IN THE MATTER of proposed Plan Change E: Roxburgh
Residential Area to the Palmerston North City
Council District Plan

STATEMENT OF EVIDENCE – RESPONSES TO SUBMISSIONS ON PARKS AND RESERVES

AARON PHILLIPS ON BEHALF OF PALMERSTON NORTH CITY COUNCIL

Dated: 16 May 2025

Figure 2: River entrance configuration vs reserve and carparking

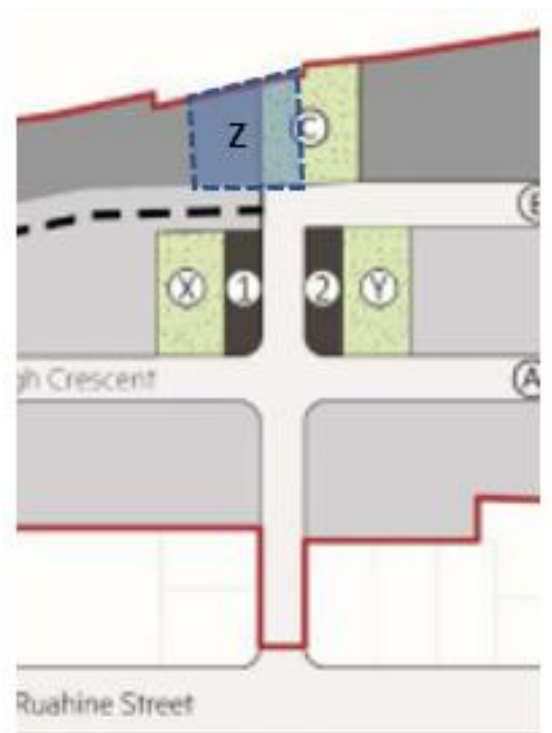
- (d) Having the reserve to the south has a modest advantage over a position to the north. The southern location provides a more contiguous flow of the open space from the Ruahine Street through to the proposed river entrance than the alternative proposed in the example in Section 3.4 of the Urban Design evidence. Under the submitters example the open space areas would be disconnected. This could be offset or remedied if the area of the river entrance at the stopbank, “Area “C” were configured to south if the reserve and carpark were to the east. See area “Z” in blue in Figure 2.
